Report to DPIE

1. Cycling intersection solutions

Street Design

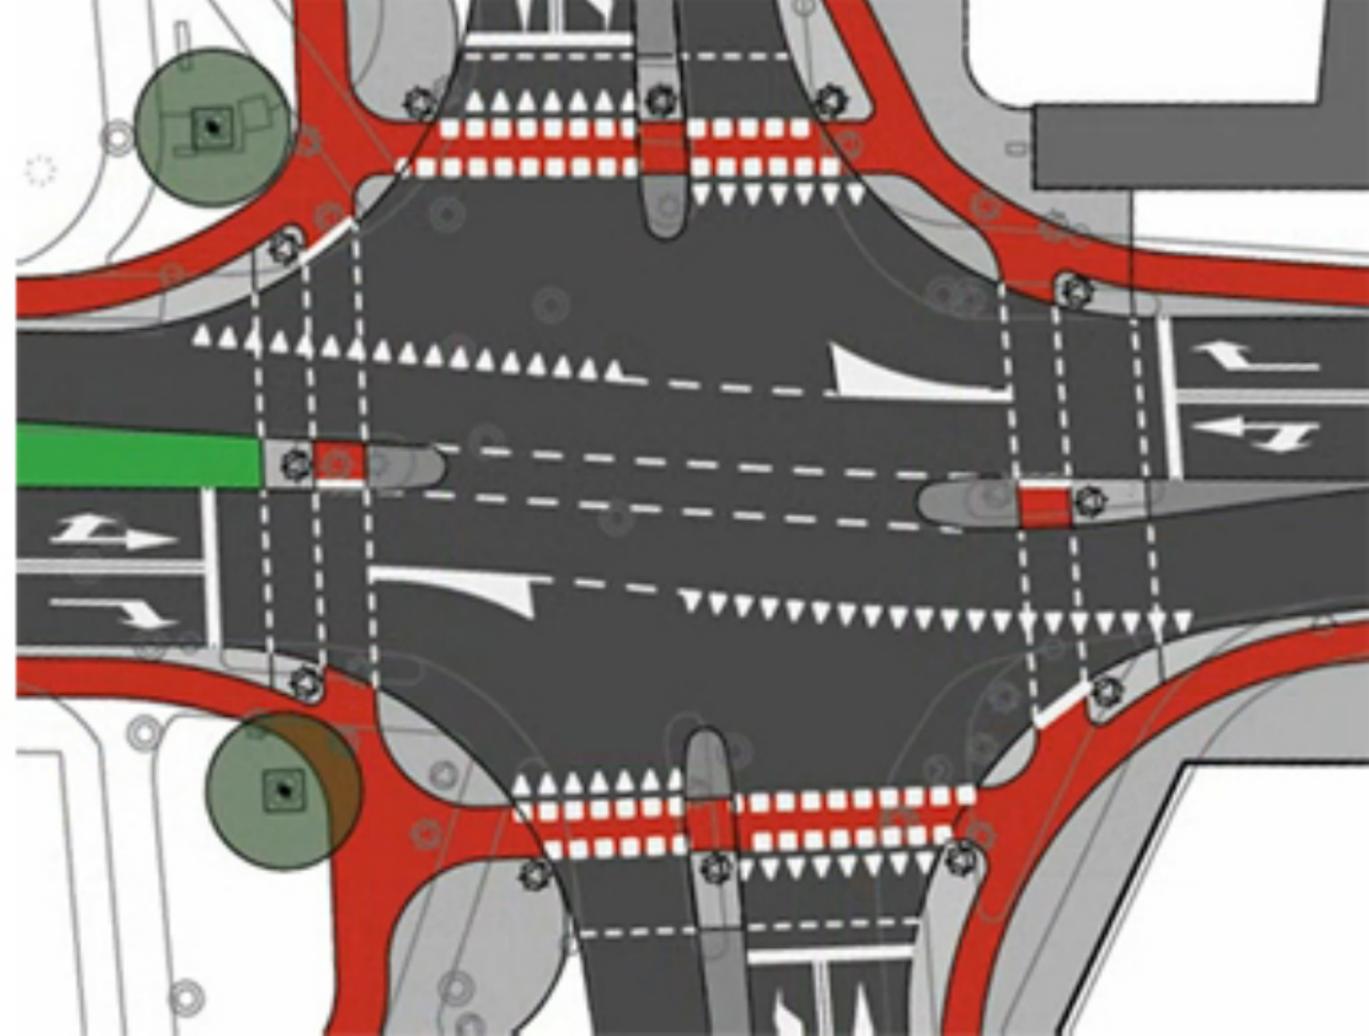
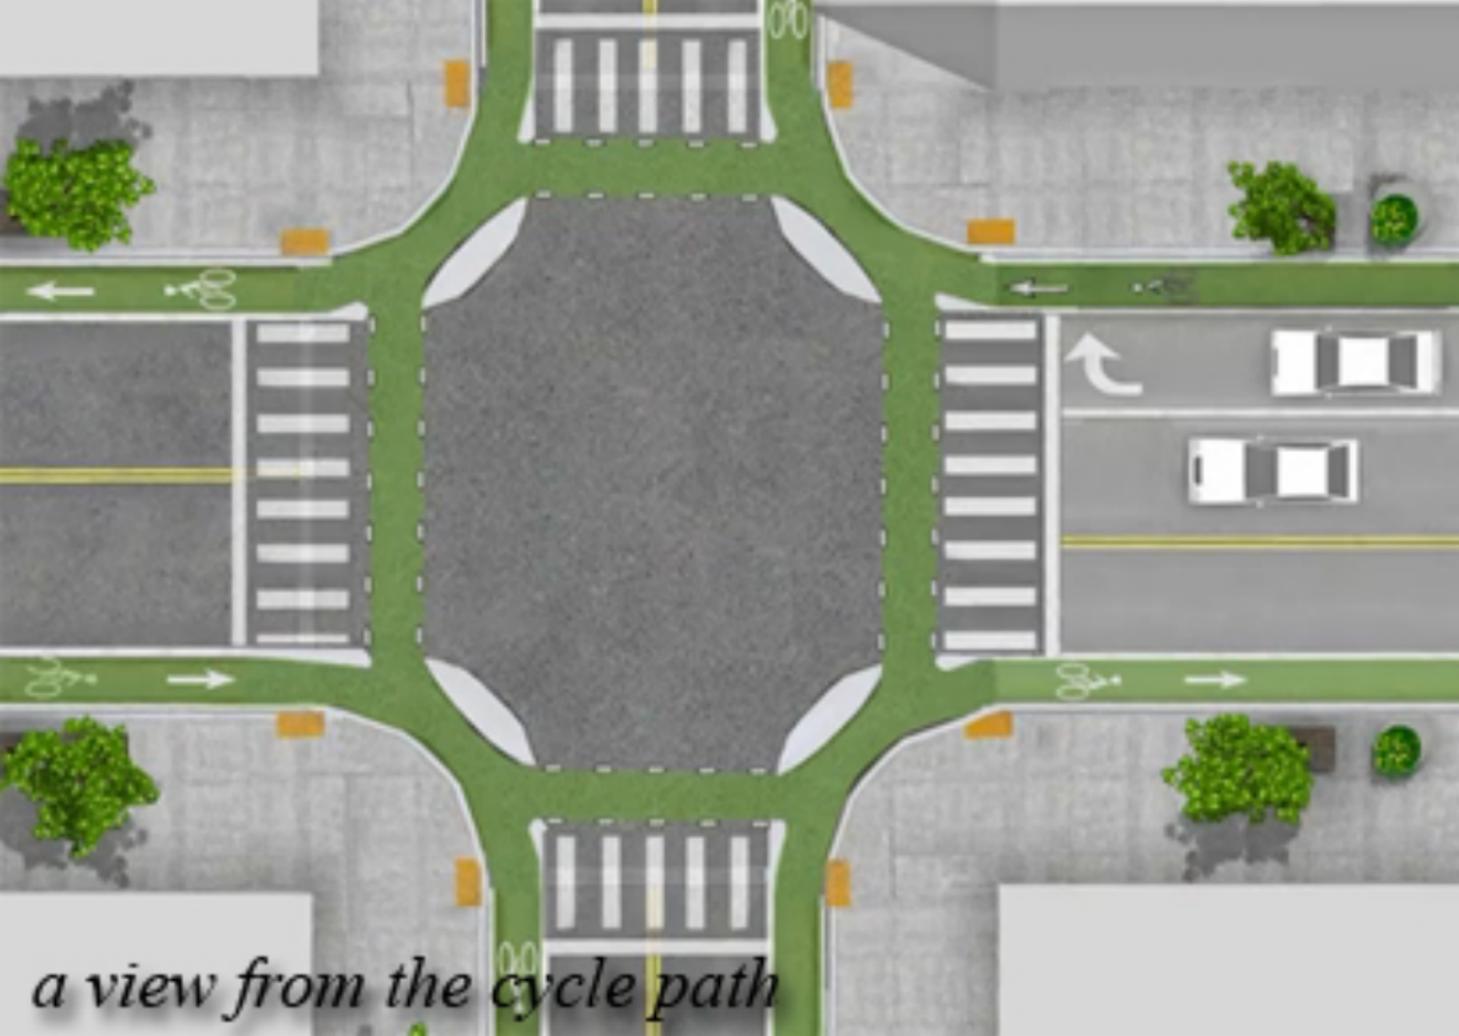
- A dedicated separated lane for cycling crossing is priority and could REVOLUTIONISE THE WAY WE EXPERIENCE WESTERN SYDNEY AEROTROPOLIS. This should not turn into a civil engineered overdimensioned solution but snug into the same space we have for other intersections, generally always slowing traffic down with tied corners (attached). Agreeing to such a solution used to be part of a DCP with at least some principle sections and floor plans showing the intent. (attached underneath)

- PO2 Prioritise pedestrian, cycle and public transport movements ***insert; with dedicated lanes wherever possible.
- PO5 All streets should be shaded ***insert; with pedestrians and cyclist as a priority***
- Table 1 - It is entirely unclear how pedestrians and cyclist are prioritised. Which street gets the dedicated cycling lane? Which have the flawed overdimensioned shared path? Where do we need a bucket of paint? And: add typologies - A. Dedicated cycle path and footpath - separated network part of park landscape, (usually connecting points of interest faster than other networks) - B. Pedestrian area with destination vehicular access only, no through traffic. While I understand it's perhaps not part of what you see as a 'street' it needs to be added in this table. If the intent is to priorities these transport modes most streets should be designed with this in mind.

Dutch Junction

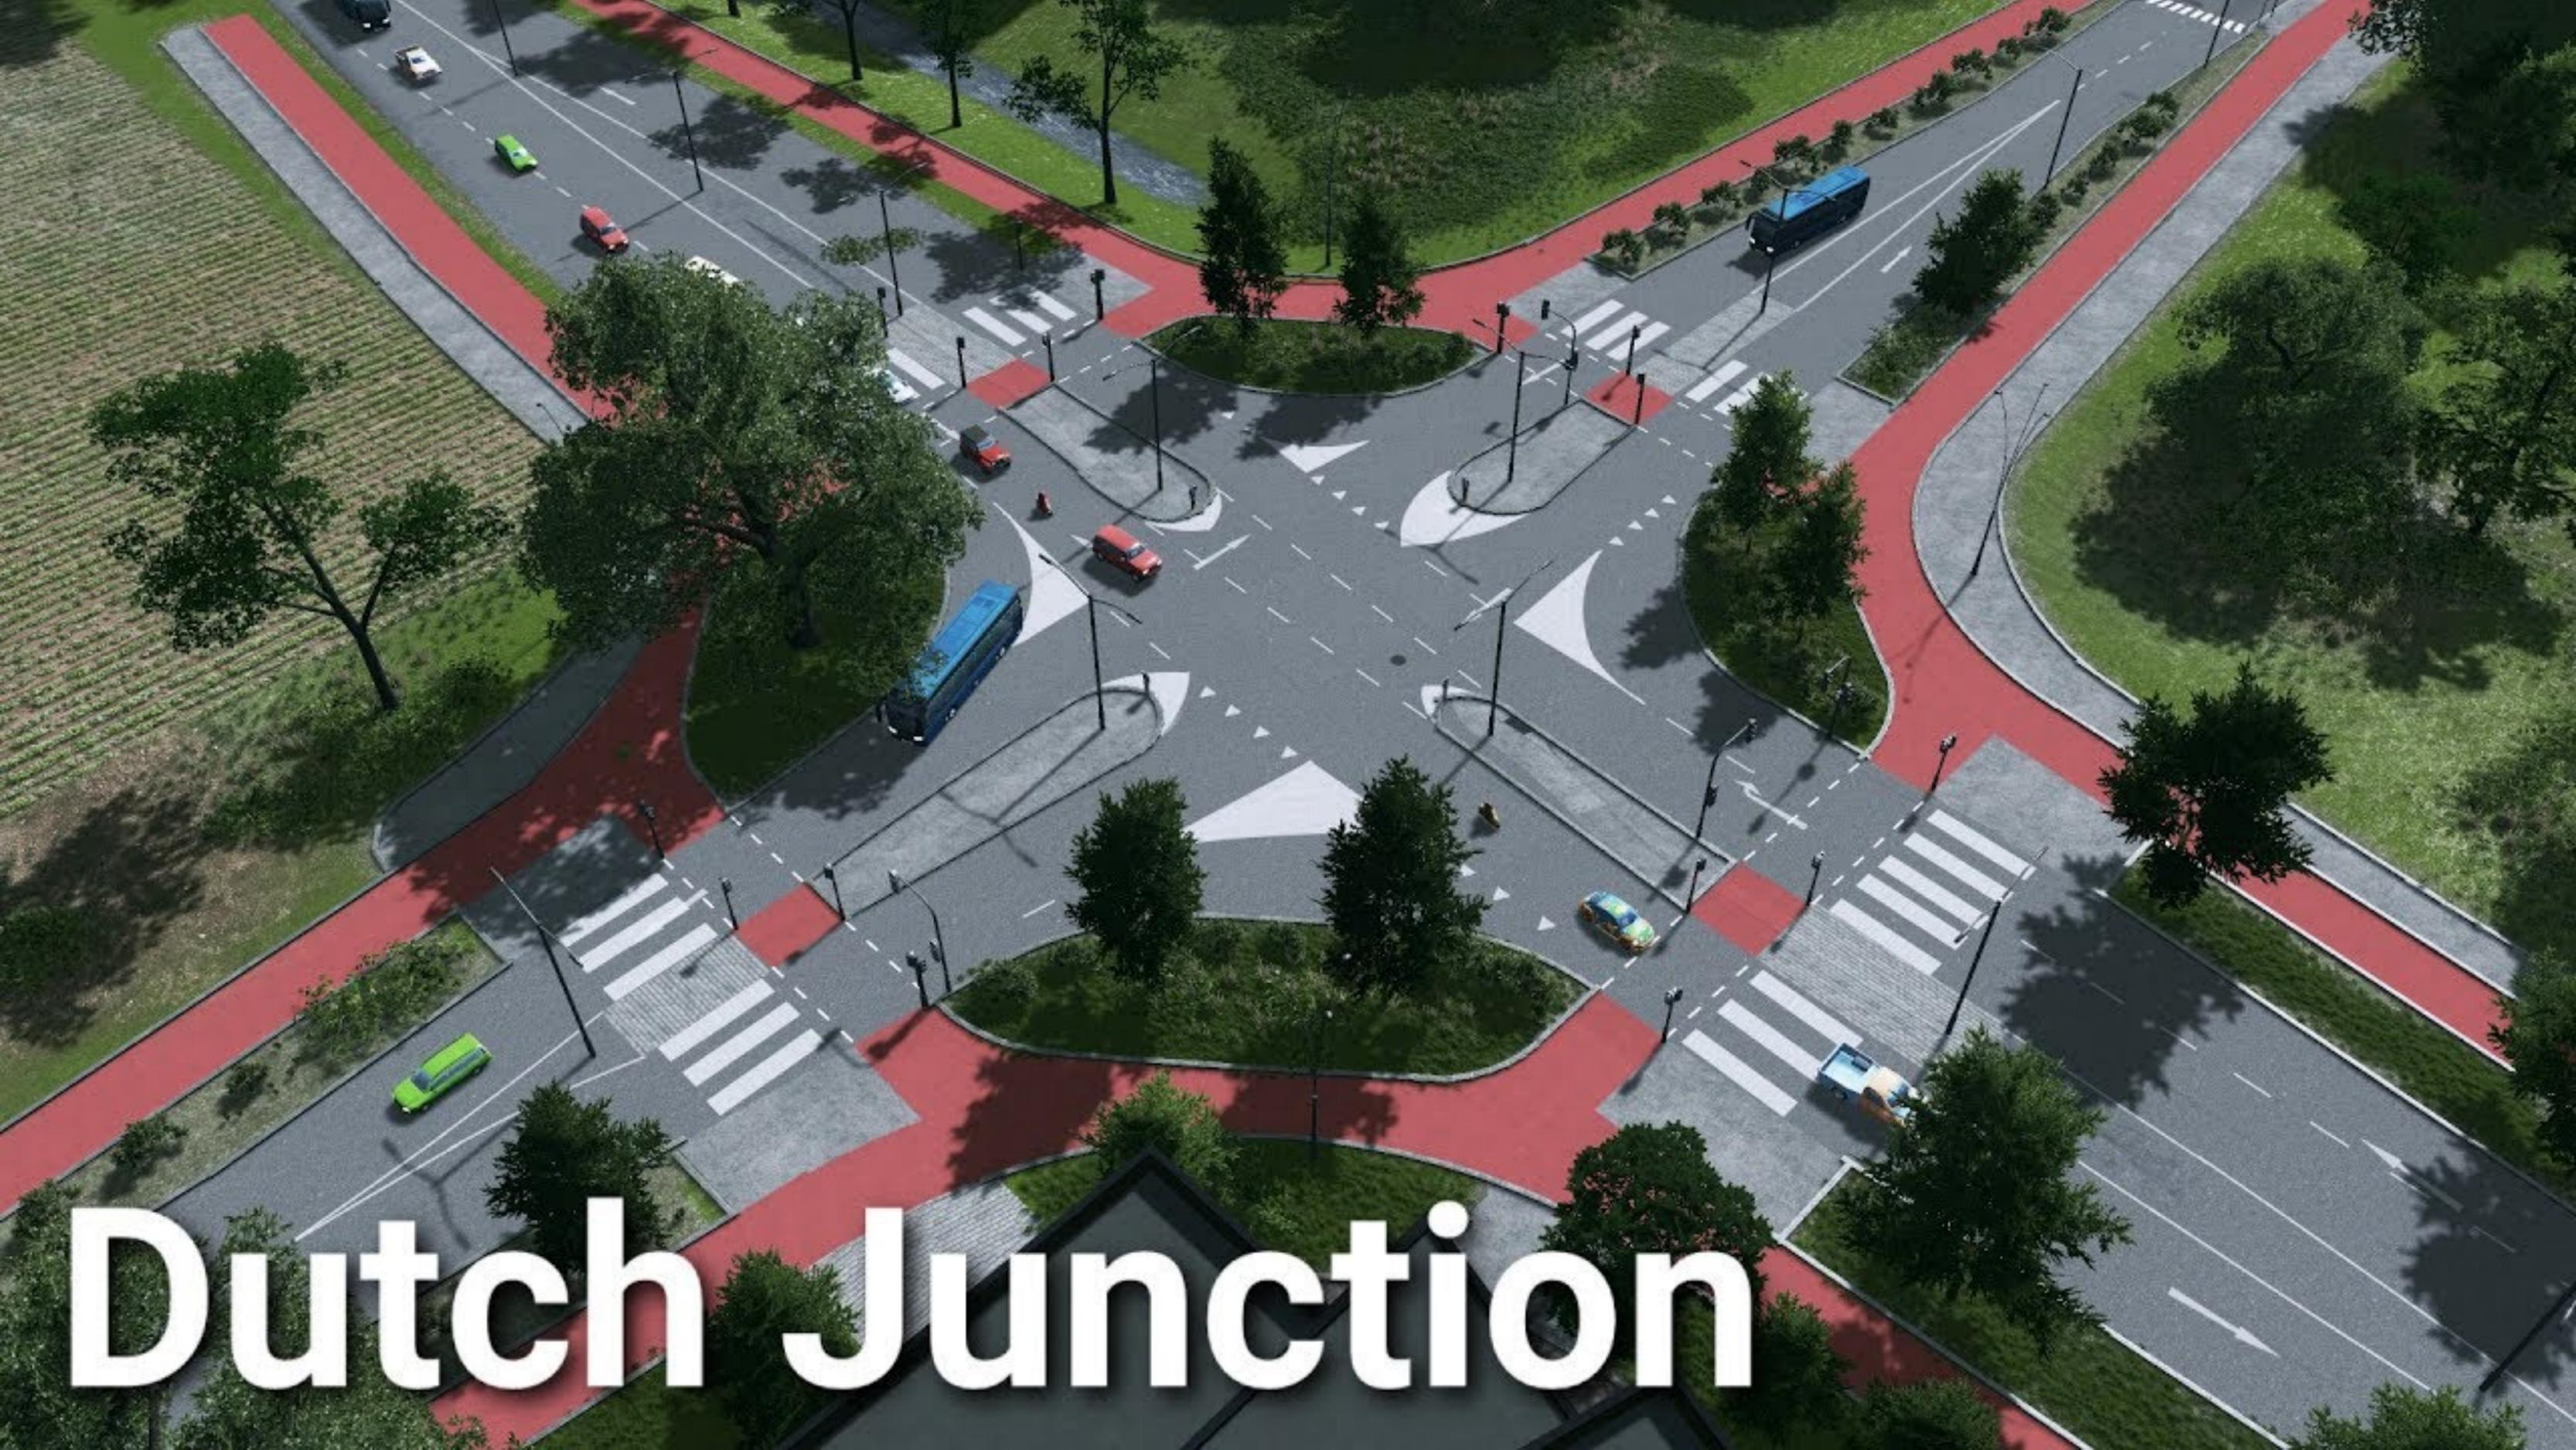
6.5m crossing distance (safe)
1) Reduce car speed before crossing
2) Easy for motorist and non-motorist to watch out for each other

Inner ring / plants
outer ring / interlocking brick, for long vehicle turing.
